USNRC APPLICATION
Combined Source and 11e.(2)
Byproduct Material License

The Reno Creek ISR Project
Campbell County, Wyoming

**ACCEPTANCE REVIEW
RESPONSE PACKAGE**

June 2013

Area of Potential Effect

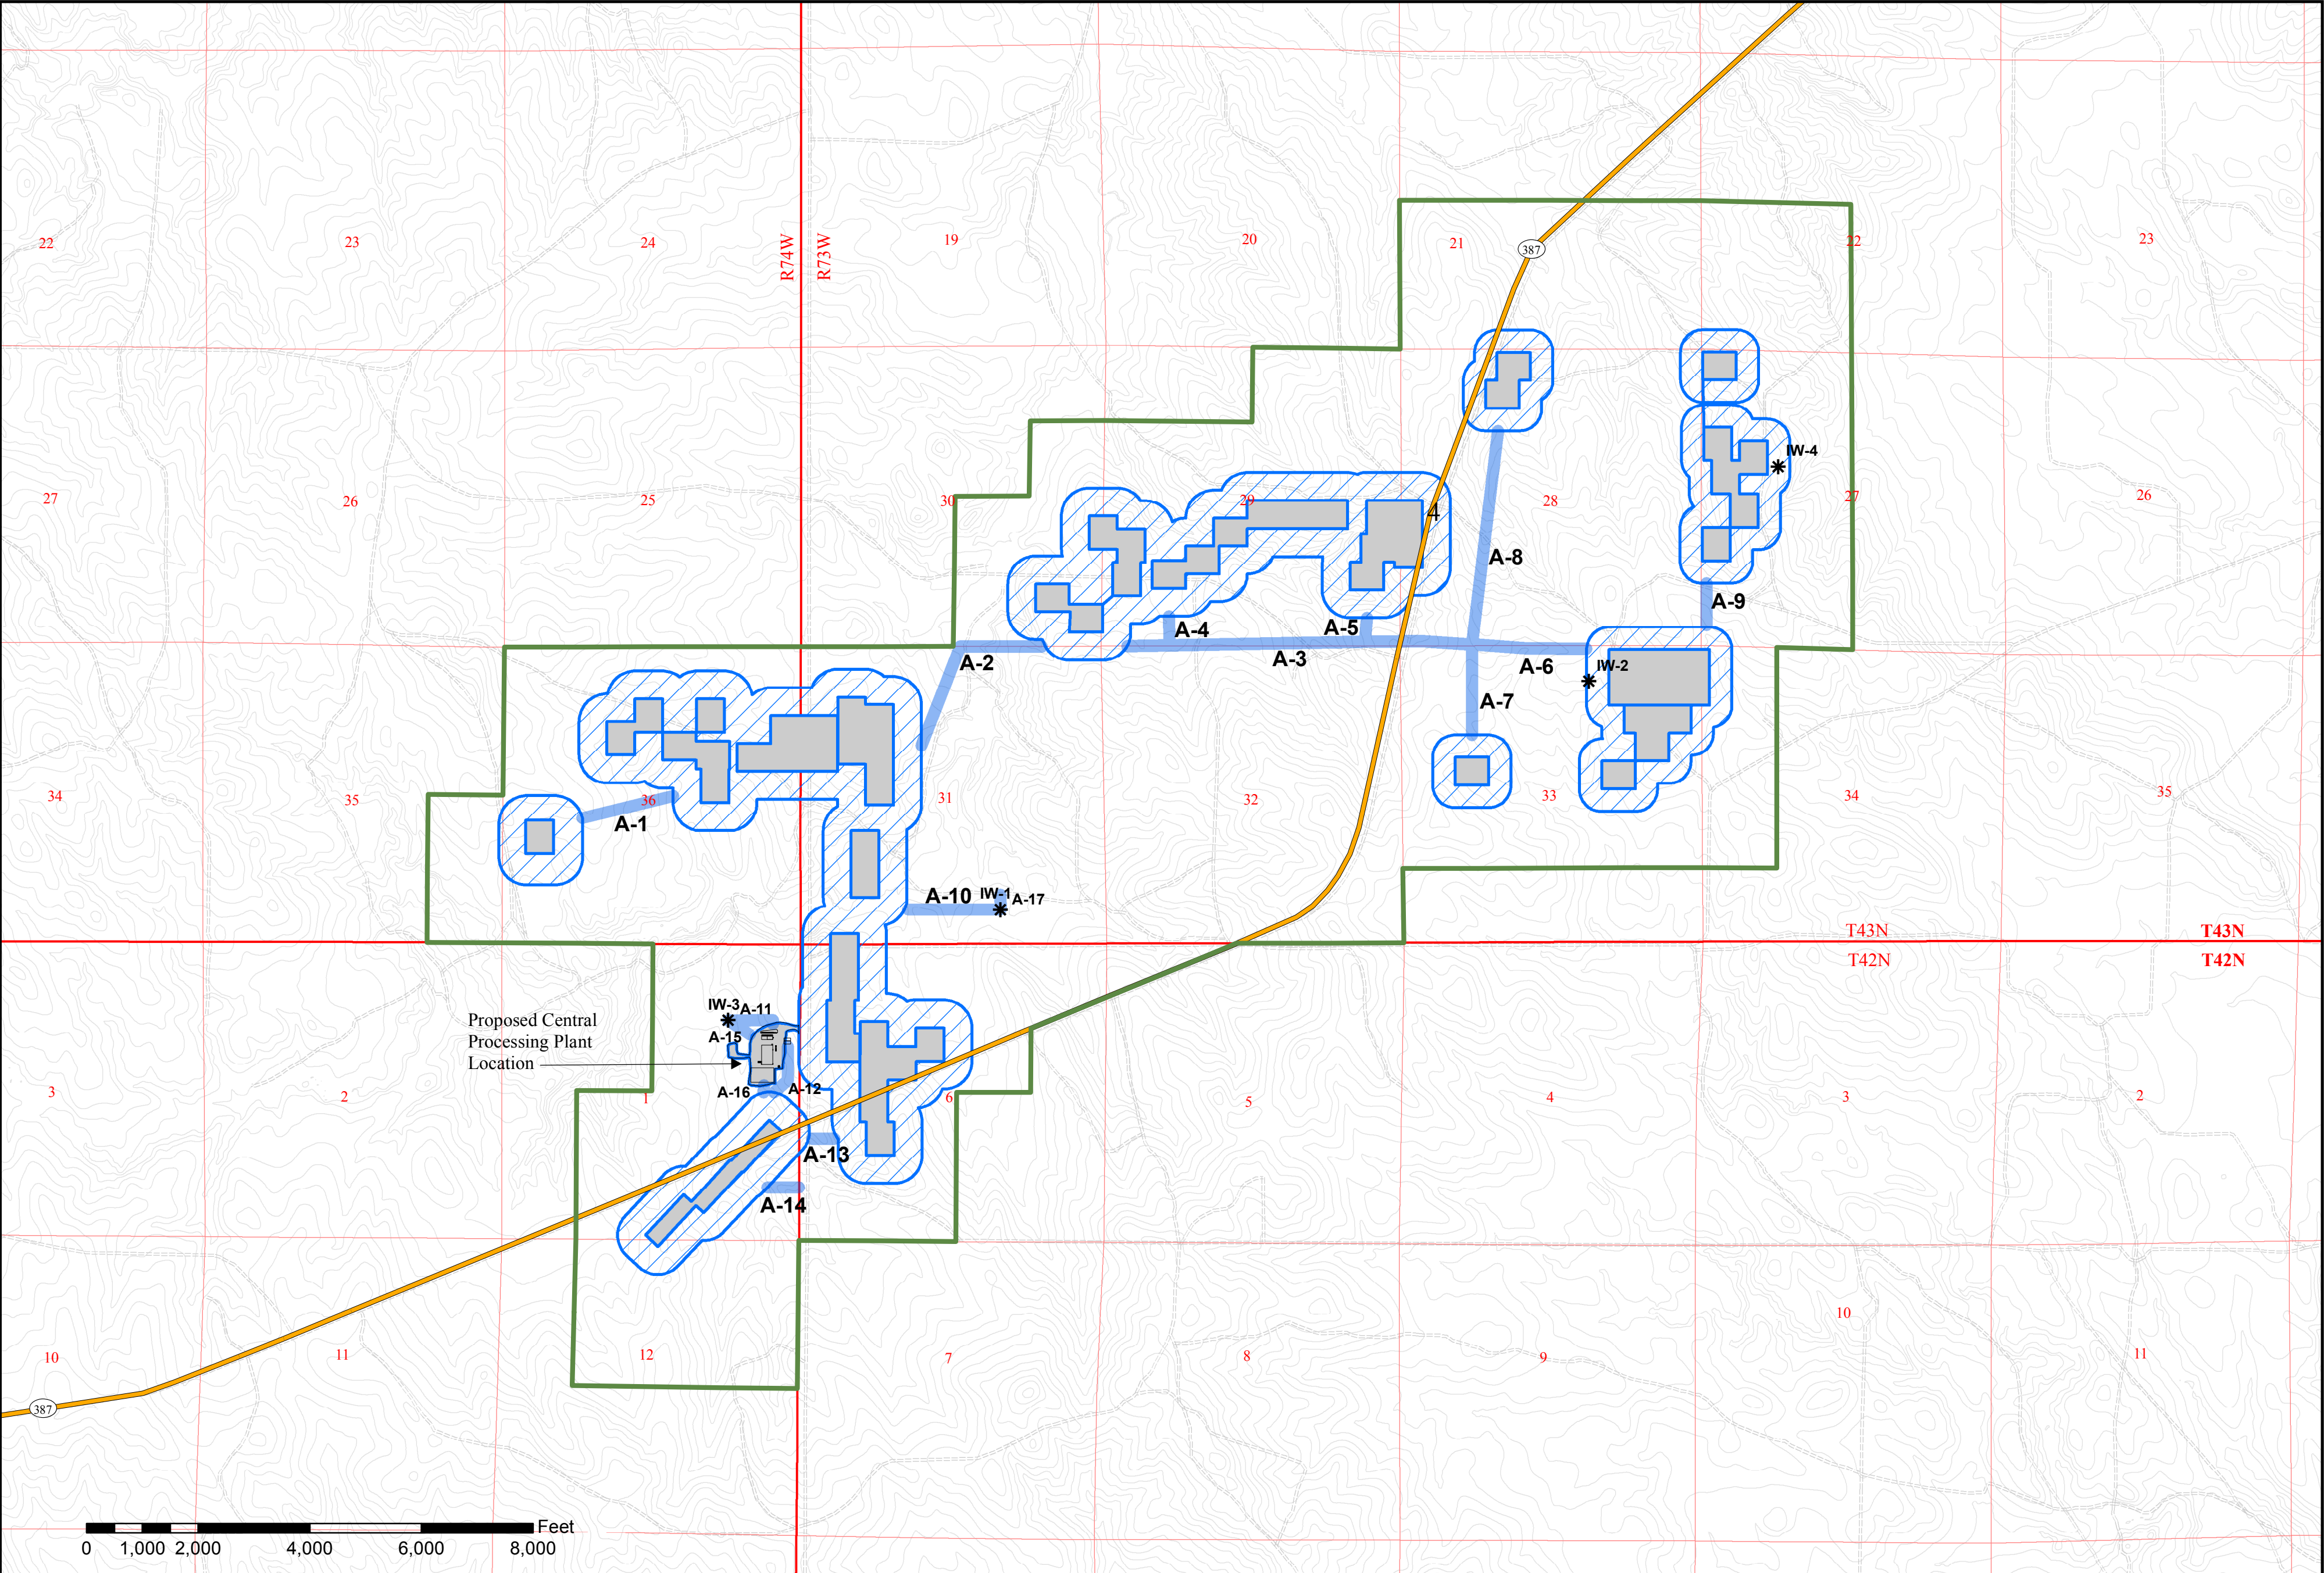
Include a description of the Area of Potential Effect (APE) and a map depicting this area.

The identified APE focuses on those portions within the Reno Creek Proposed Project Boundary which will contain all of the anticipated disturbance and ongoing activities of the project. The APE was developed after the completion of the license application; thus, includes all anticipated disturbance creating activities. It does not exactly correspond to several geographic areas specifically designated otherwise in the AUC license application. Three geographic areas related to disturbance were used in the license application:

The boundary of the Controlled Area in the wellfield/production unit portion of the project is at the edge of the producing wellfield. Lying 400 to 500 feet outside of the wellfield/Control Area will be the ring monitor wells. While it is the intention of AUC to disturb only each monitor well site, limited road construction or other disturbance may occur between the wellfield and the monitor well ring and between each monitor well. Thus, the area between the monitor well ring and the Controlled Area should be included in the APE. This area incorporates approximately 1,119 acres, as shown on the attached figure titled "Area of Potential Effect".

In addition, pipelines and new roads and/or power lines may be constructed between the CPP and wellfields and between wellfields, in areas that are not in a Controlled Area. These limited areas should be incorporated in the area subject to tribal surveys. These corridors contain approximately 8.7 acres, as shown on figure “Area of Potential Effect”. The table below provides the estimated acreages for each of these corridors.

Thus, the total acreage that should be included in the APE is estimated to be 1,609 acres.

Visual APE Evaluation along
Reno Creek Project Public Roads

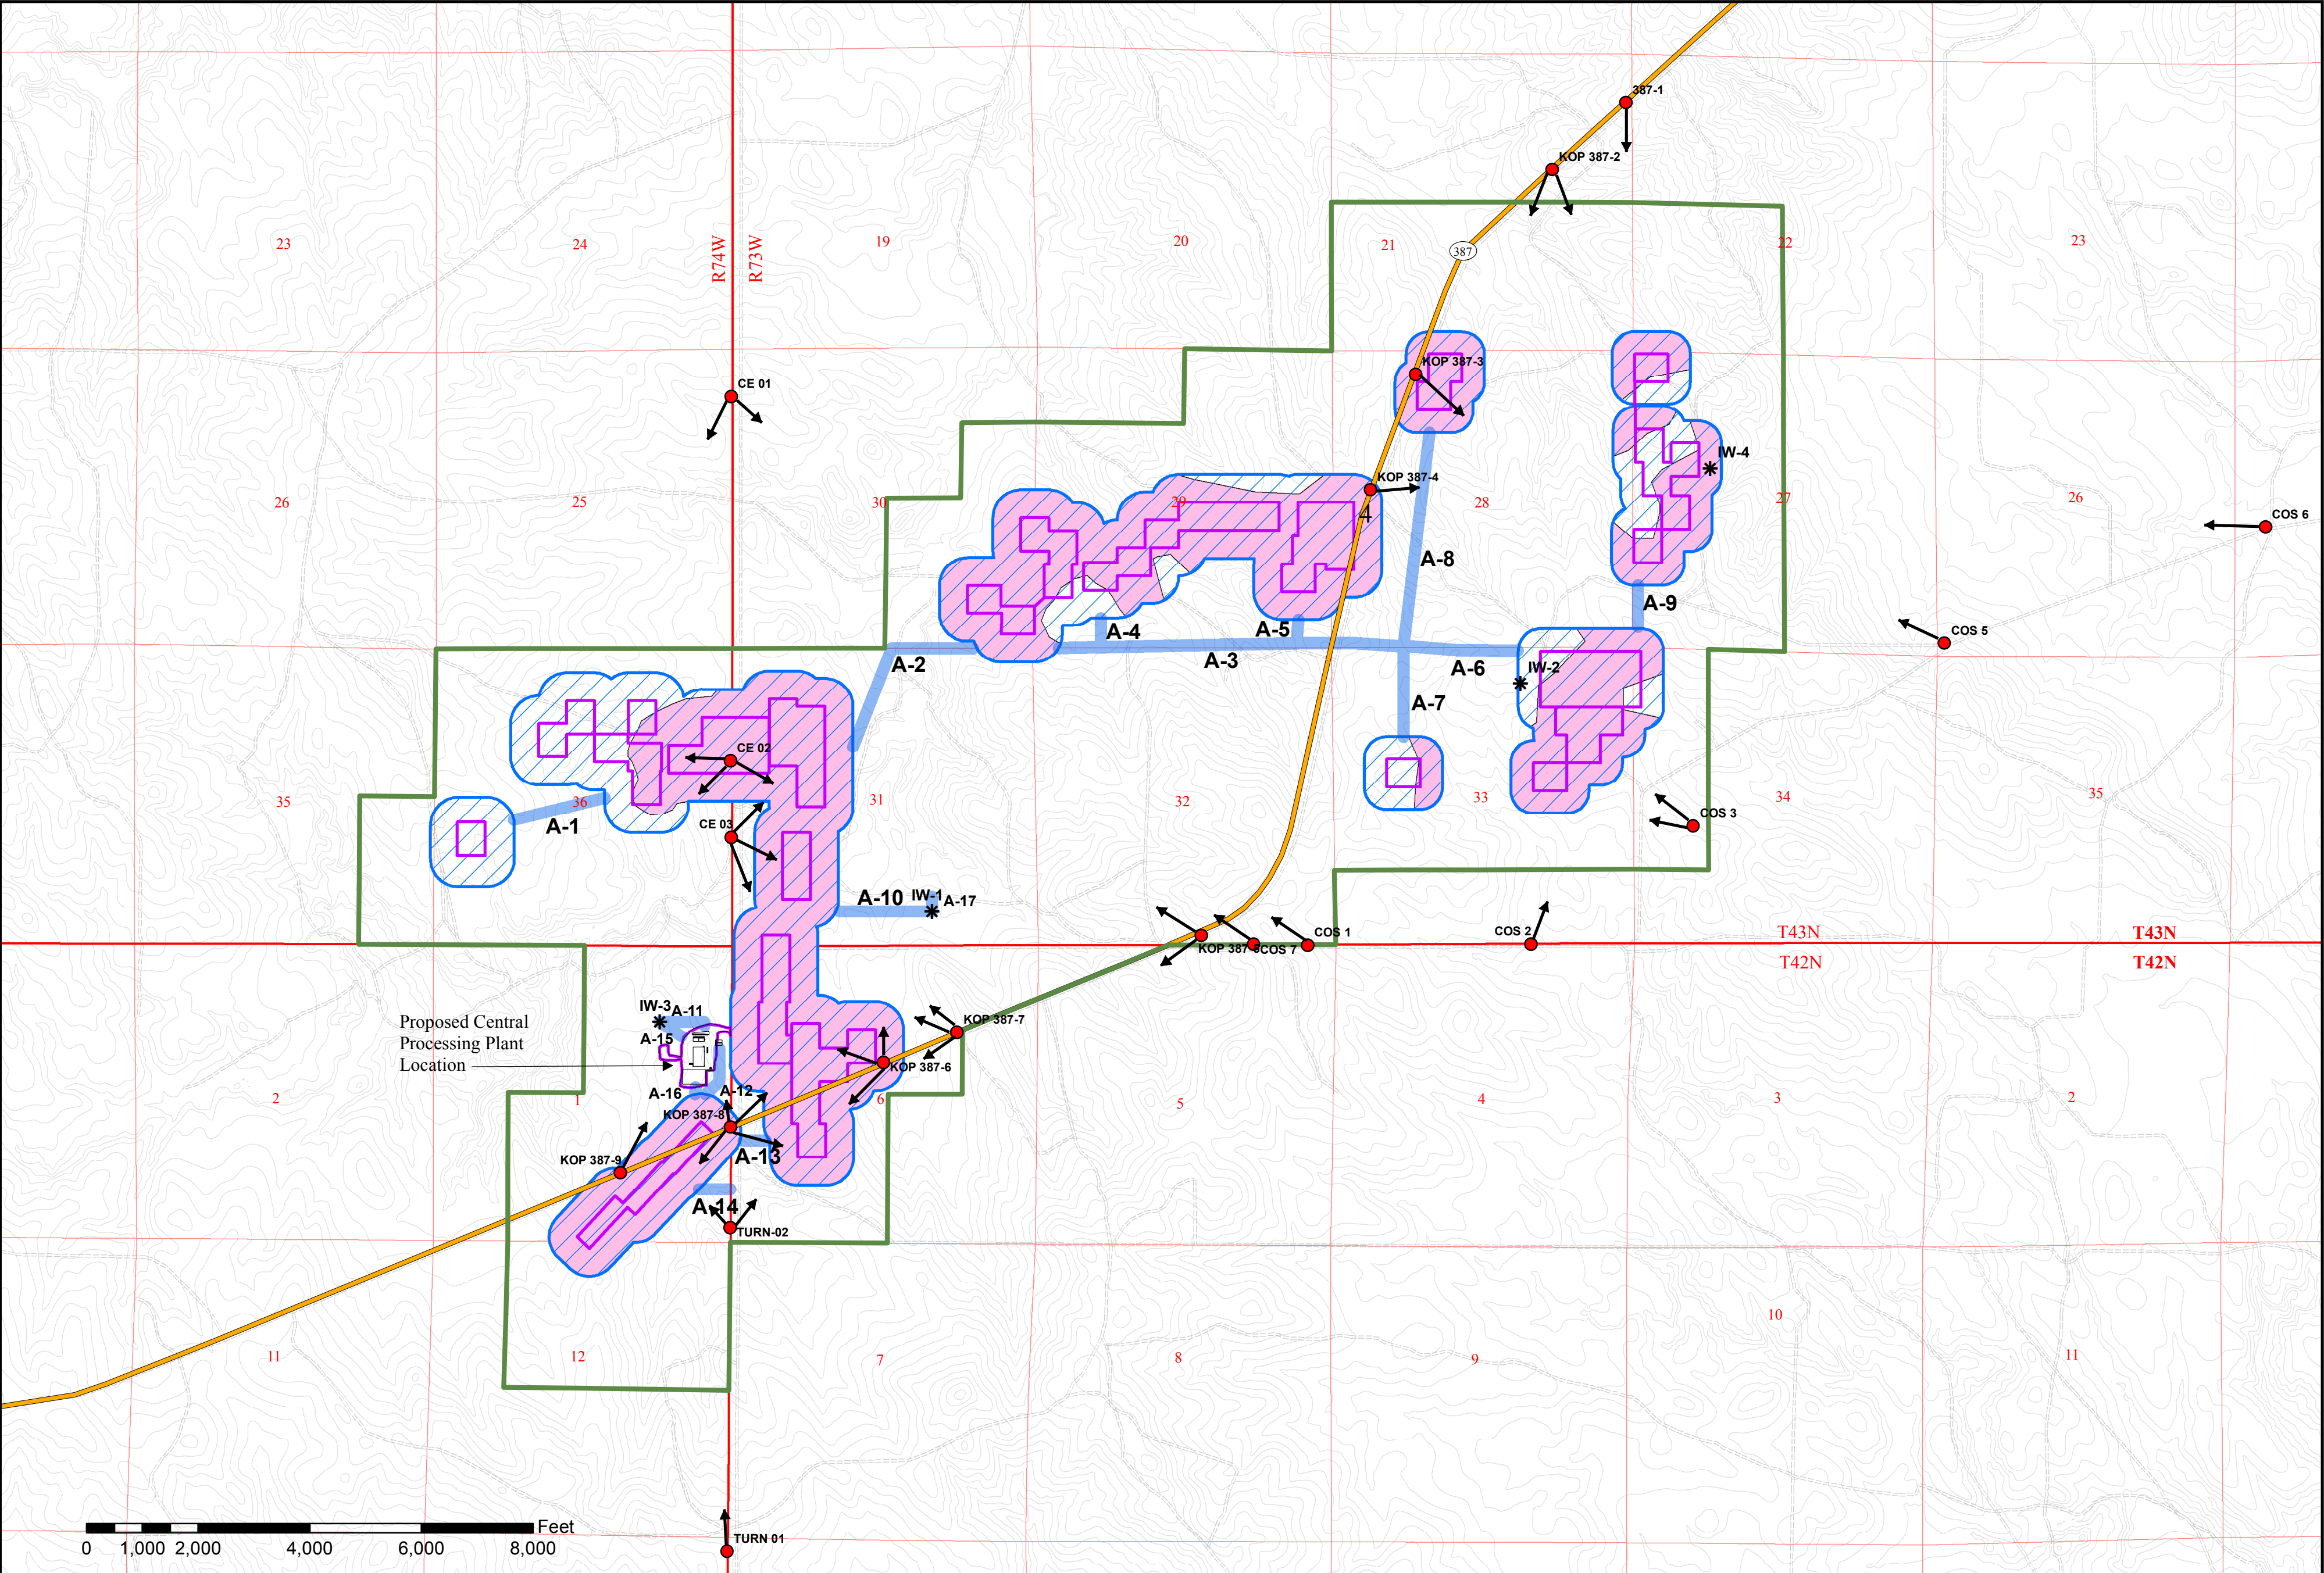
Include a viewshed map depicting the proposed operational areas potentially visible along the following public roads: Wyoming State Highway 387; Cosner Road; Turner Crest Road; and Clarkelen Road.

AUC conducted a visual APE evaluation along the proposed Reno Creek Project public roads on May 29, 2013. This evaluation was conducted to identify those portions of the proposed project operational areas which were noted to be visible, specifically along the following public roads: Wyoming State Highway 387; and Campbell County roads including Cosner Road; Turner Crest Road; and Clarkelen Road. AUC previously conducted a viewshed evaluation using the BLM Visual Resource Management (VRM) system (BLM Manual 8400, 2007) to evaluate the scenic resources for visual appeal of the Reno Creek Project area. The visual APE evaluation result is considered part of the VRM and does not alter the previous study results developed in July 2011, which shows the visual resource evaluation rating as 19 or less, a rating which does not require further evaluation for existing scenic resources and any changes to scenic resources from the proposed project facilities

Below is a viewshed map depicting the APE visible along the public roads that traverse the proposed Reno Creek Project area.
